Technical Memorandum

Background Uranium Concentration

Homestake Millsite, Grants New Mexico

Prepared by: Tom Myers PhD

Figure 6: Location and groundwater level elevation of near and far-upgradient alluvial wells near the Large tailings pile. Source: Homestake (2015) Figure 2-3.

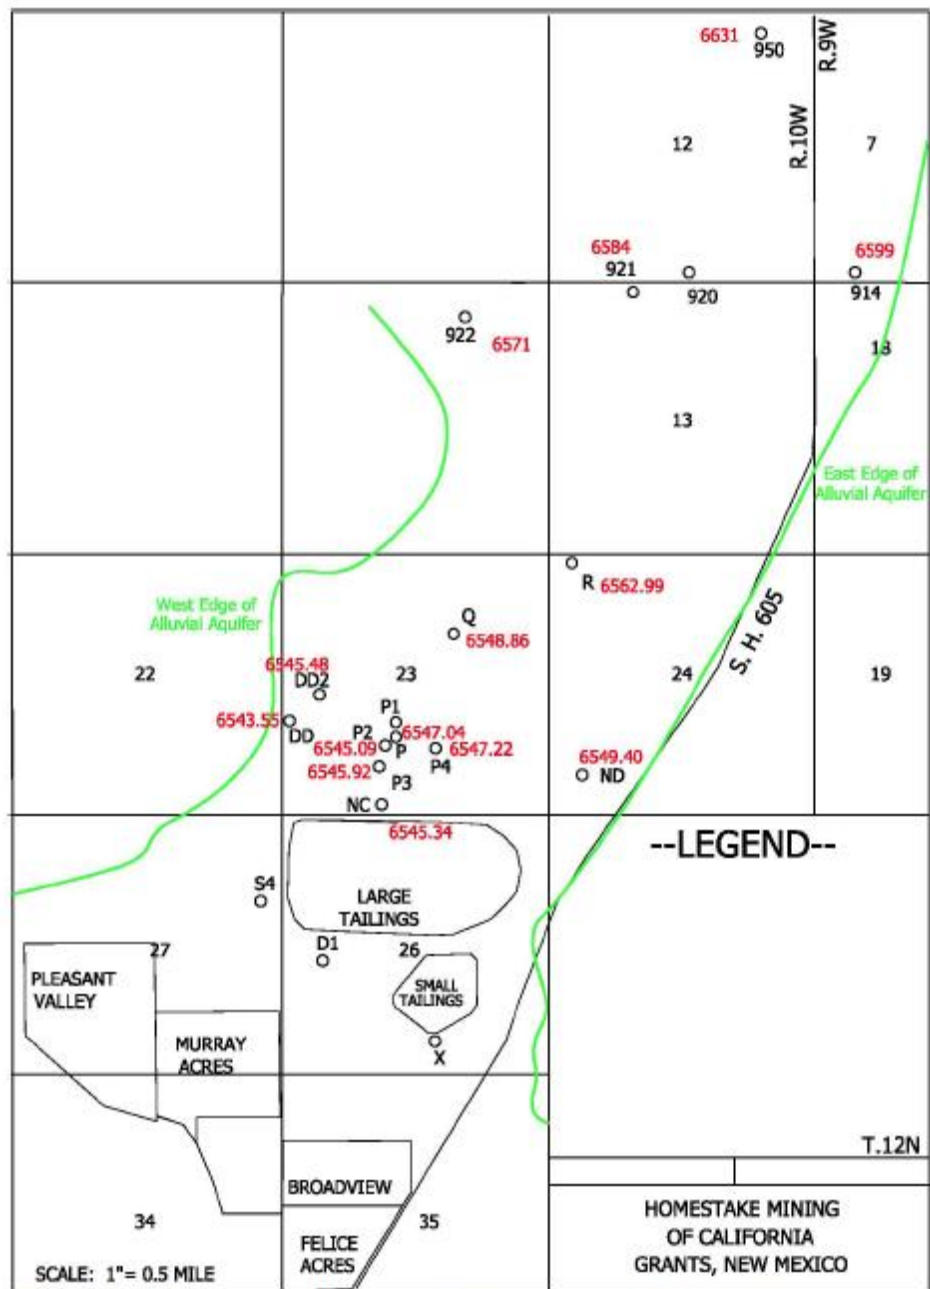
Figure 6 shows near-upgradient wells (ND, DD, P, P1, P2, P3, P4, Q and R) and well DD2, far-upgradient wells (914, 016, 920, 921, 922, and 950), and their 2013 water level elevations. HMC used these wells to determine background (NRC 2006). Far-upgradient well water levels are about 20 feet higher than at the near-upgradient wells. The water surface elevations for the near-upgradient wells vary by less than 5 feet with the water levels under the LTP. These water level observations do not contradict the hypothesis presented by Myers (2015) that over time mounding under the LTP could have reversed the gradient and been responsible for high U concentrations in wells upgradient from the LTP.

Figure 7: Uranium concentrations for the far-upgradient alluvial wells. Source of data: Homestake digital groundwater chemistry database

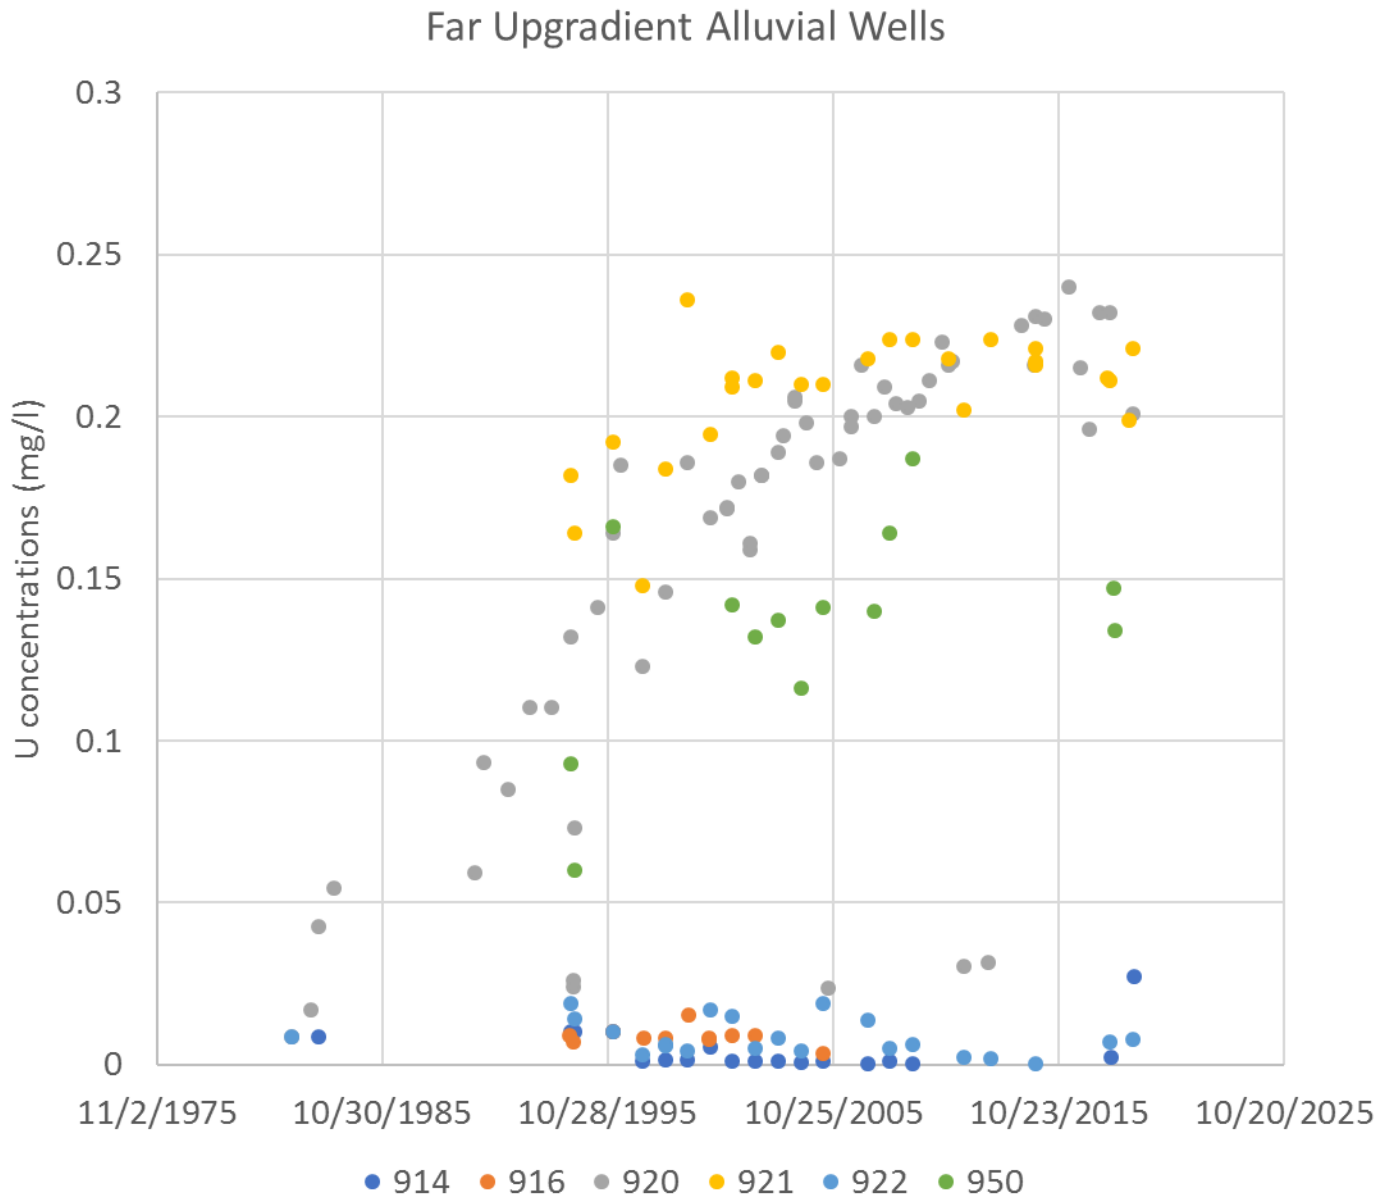
U concentrations at the far-upgradient wells trend upward which reflects the downstream advection of U from upstream millsites (Figure 7). None have 1970s data, but the earliest observations are less than 0.05 mg/l. Wells 920, 921 and 950 show a distinct upward U concentration trend that does not occur at wells 914 and 922, which lie east and west, respectively, of the other wells. U concentrations at well 916 which begin in the early 1990s are very low whereas concentrations at 921 exceeded 0.15 mg/l. U concentrations at the far-upgradient wells were low, less than 0.03 mg/l, prior to discharge from upstream mines and mills reaching the area.

Figure 8: Uranium concentrations for the near-upgradient alluvial wells. Source of data: Homestake digital groundwater chemistry database

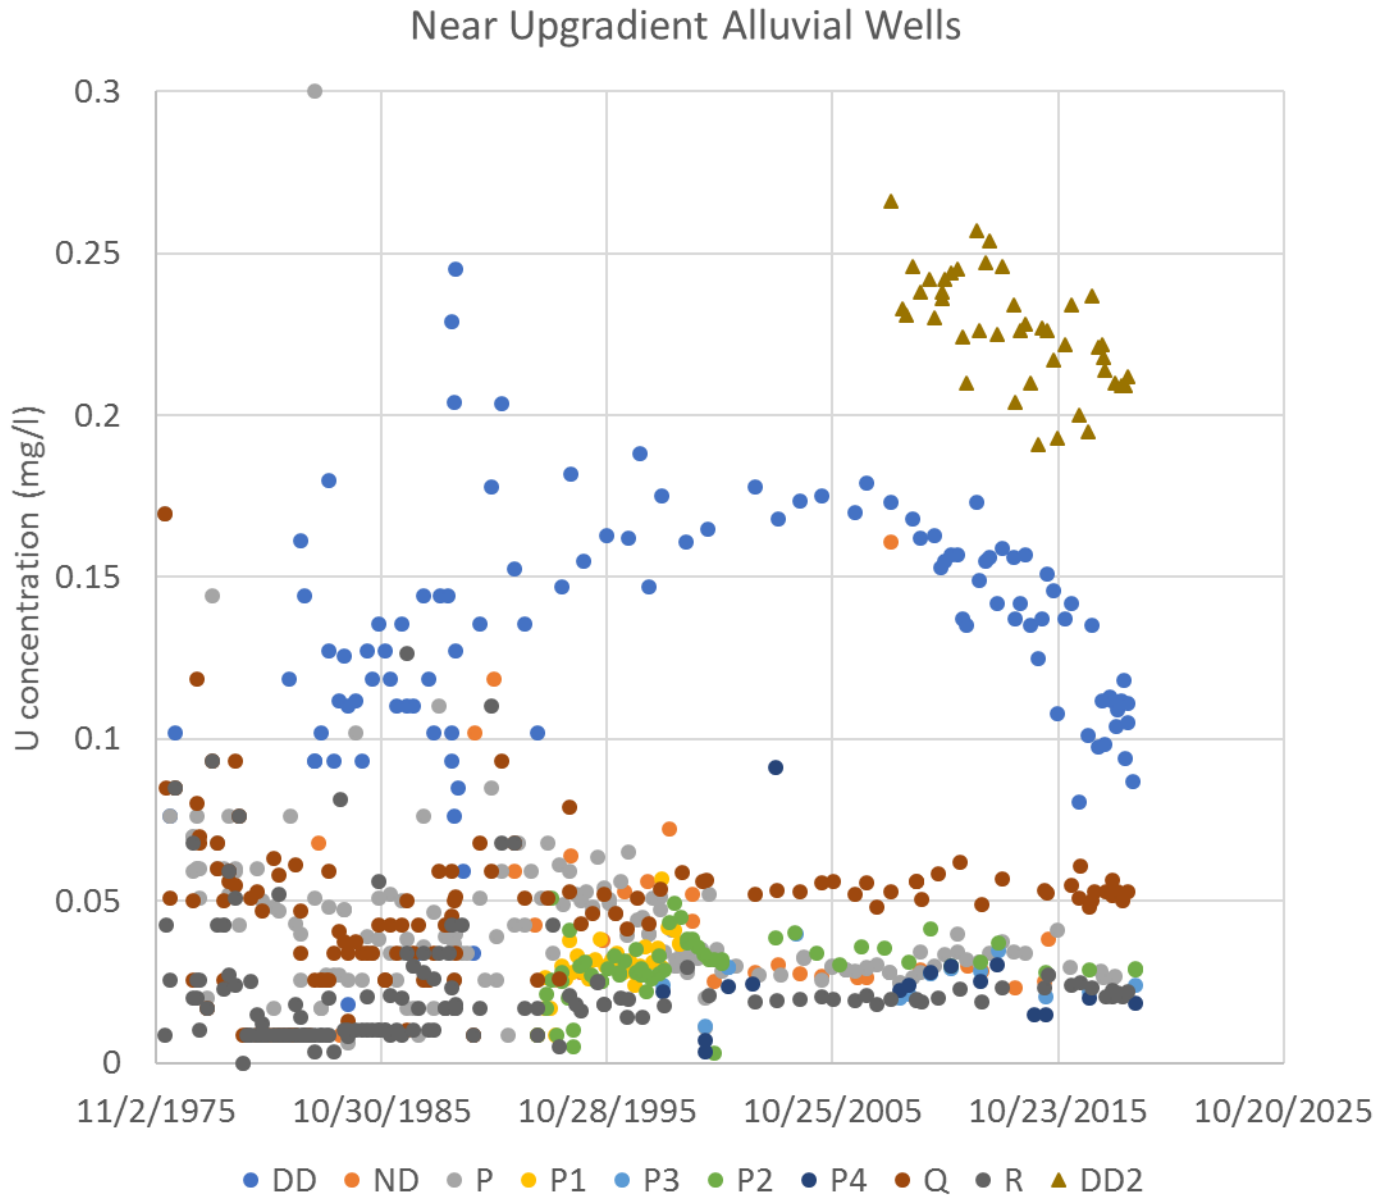
U concentrations at the near-upgradient wells support Myers (2015) hypothesis that U advection from the LTP caused occasional high U concentrations or spikes in many of the wells between 1975 and about 1985 (Figure 8). After 1985 the concentrations generally decreased to less than 0.06 mg/l, with well DD being an exception. Concentrations at well DD reflect a different source related to U transport that has primarily occurred west of the LTP. Well D2, which was not used for the determination of background U concentrations but lies in the high-U pathway (Figure 4), has high concentrations subsequent to 2008.

Frequency plots of the near-upgradient well data for 1995 through 2004 show the major effect on calculated background caused by well DD (Figure 10). With DD data, the 95% exceedance is about 0.16 mg/l which corresponds to the Homestake-estimated background, but without DD, it is about .054 mg/l. The higher U values occur at well Q which exhibits relatively stable values around 0.05 mg/l after some fluctuation prior to 1985 (Figure 8). The median value for each is about 0.03 mg/l.

A reasonable background value for U in the alluvium is 0.04 mg/l based on three factors. The 95% exceedance value at the near upgradient wells without well DD is 0.05 mg/l. However, the far upgradient wells and wells southwest of the LTP commenced at concentrations less than 0.03 mg/l but there are few observations from either point. Due to the limited number of observations, it is difficult to include this data in a frequency distribution using near upgradient wells for which there are many observations. Statistics based on many observations at some wells and few at others are controlled by the wells with many observations. Therefore, I adjusted the 95% value determined using statistics for the near upgradient wells to a recommended background equal to 0.04 mg/l.

Figure 9: Comparison of water chemistry at well DD as compared with wells P, Q and R. Data source: HMC database

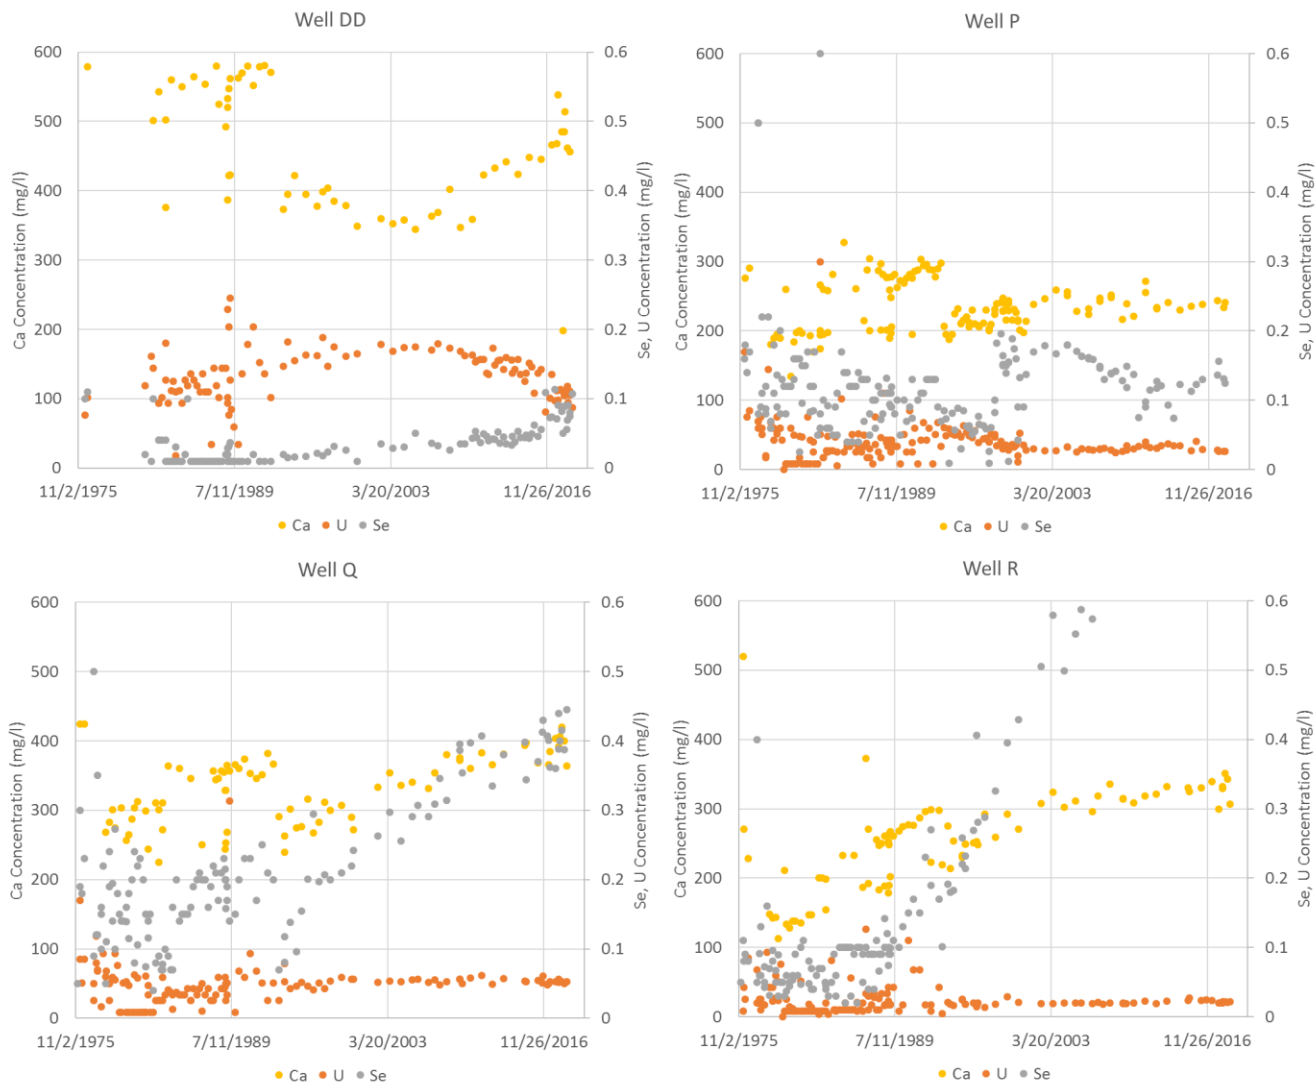
Water chemistry data for well DD compared to other background alluvial wells further demonstrates how unusual well DD is. While it has the highest U, it has the lowest Se and highest Ca values (Figure 9). These substantial differences support a hypothesis that the water at well DD originated from a different

source than the water at other alluvial background wells (Figure 9 shows wells DD, P, Q, and R because these have a data set that spans the period). The source of the U in the portion of the alluvium that affects groundwater west of the LTP and the subdivisions, upgradient mines and milling or natural sources, is not relevant to background throughout the remainder of the alluvium.

Figure 12: Uranium concentrations for the Upper Chinle zone wells. Observations for well CW3 that are higher than 0.2 mg/l, some as high as 3.0 mg/l, after 2002, are not shown. Source of data: Homestake digital groundwater chemistry database

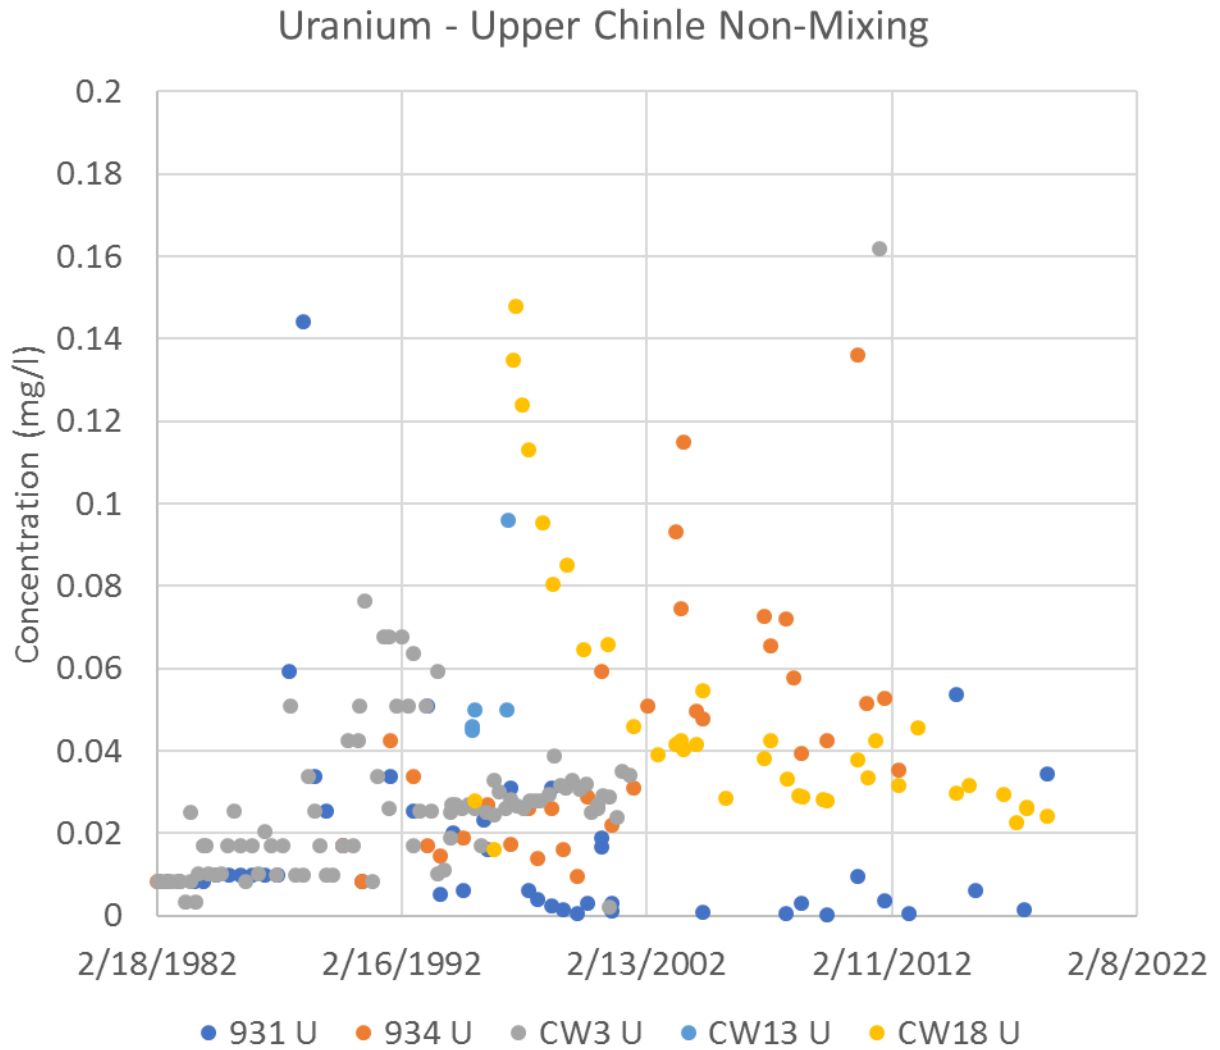
Prior to 1987, all Upper Chinle HMC background well concentrations are less than 0.04 mg/l (Figure 12). Between 1987 and the early 1990s, there was a rapid increase up to close to 0.1 mg/l. Starting around 2003, one well, CW3, increased to as much as 3 mg/l. All Upper Chinle monitoring wells show influence from millsite alluvial uranium starting around 1985 (Figure 12). This is due to seepage from the LTP into the alluvium in the 1970s reaching the Chinle in the time it takes to reach the base of the alluvium.

Wells CW3 and 931, close to the northeast corner of the LTP and southeast of the LTP, have low concentrations prior to 1985 but then trend upward (Figure 12). These wells have low U concentrations early in the period because they are far from the subcrop. Measurements at well 934, further southeast of the LTP, started a few years later at concentrations similar to CW3 and 931. CW18 concentrations started at over 0.14 mg/l and dropped through the years as cleaner water entered the aquifer.

U concentrations for wells CW3 and 931, which are apart from the East Fault and the subcrop, are least affected by tailings seepage and therefore are most likely to represent natural background. A reasonable background for the Upper Chinle non-mixing zone is 0.03 mg/l based on concentration data prior to 1987 at CW3 and 931.

Figure 13: Uranium concentrations for the Upper Chinle mixing zone wells. Source of data: Homestake digital groundwater chemistry database

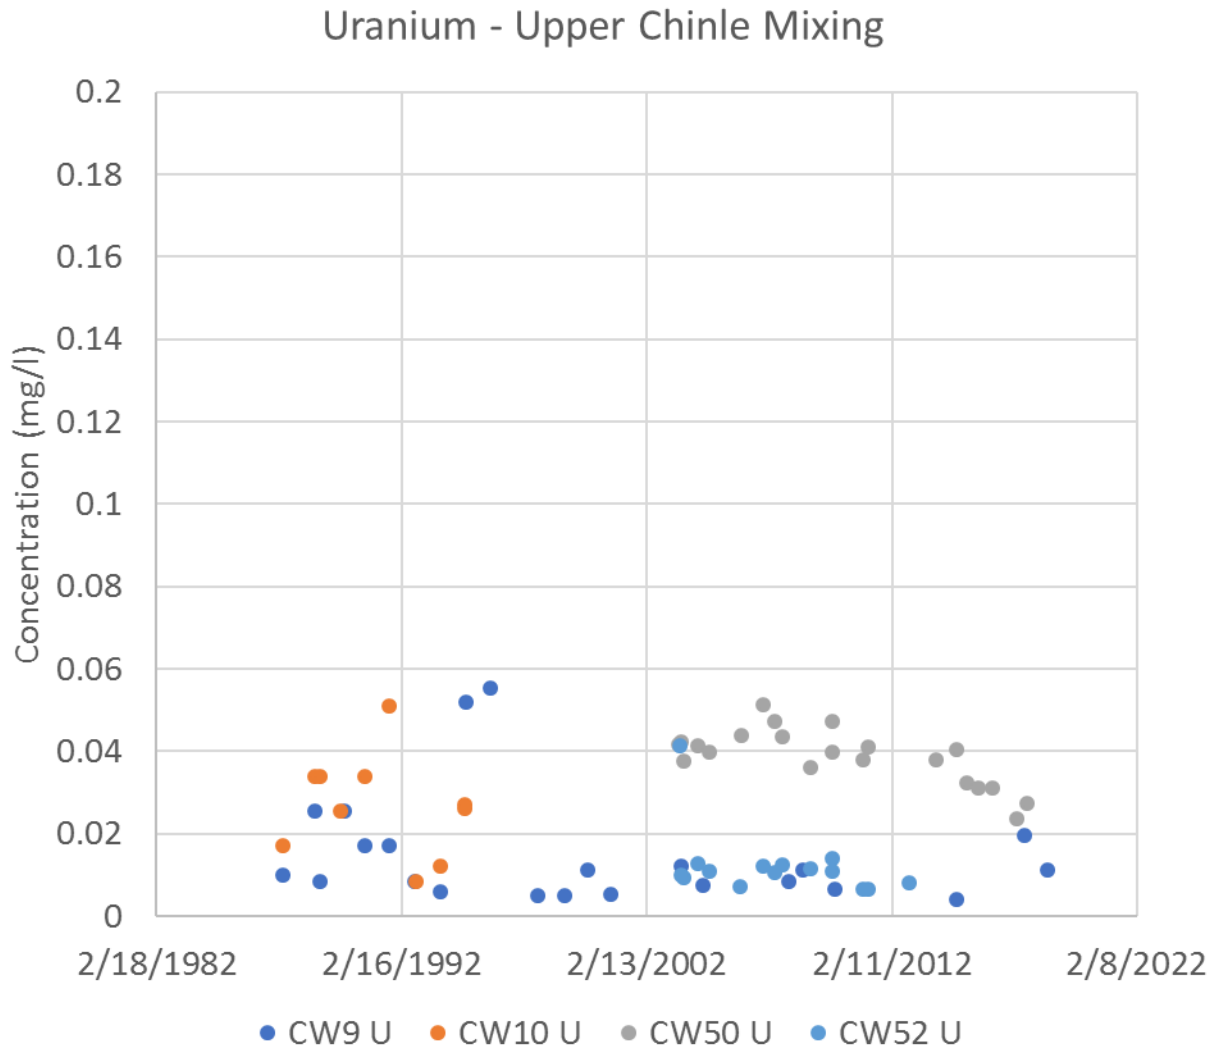
Mixing zone wells for the Upper Chinle show concentrations that are generally less than 0.06 mg/l (Figure 13). Two of these wells (CW9 and CW10) are directly beneath the south portion of the LTP and two (CW50 and CW52) are substantially north of the LTP. Further east and south, spot measurements in the mixing zone show how U contamination spread into the Upper Chinle. Three wells from the Felice Acres area show substantial increases from background to concentrations reflecting seepage. Well 445 had U equal to 0.025 mg/l in 1976 before rising to over 1.6 mg/l in 1982. In 1981 well 485 U was non-detect U. In 1983, well 486 had U concentrations equal to 0.019 mg/l. These measurements which preceded substantial increases in U in the Upper Chinle in Felice Acres reflect background before any impact.

For the upper Chinle mixing zone, different wells are presented at different times rendering it difficult to determine trends (Figure 13). Overall, concentrations are generally less than 0.06 mg/l with the two wells that have data prior to 1990 being less than 0.04 mg/l. No trends are apparent except that data collected later in the period are higher than those collected earlier, but from different wells. Middle Chinle concentrations substantially exceeded 0.05 mg/l with three exceeding 0.10 mg/l at four of the
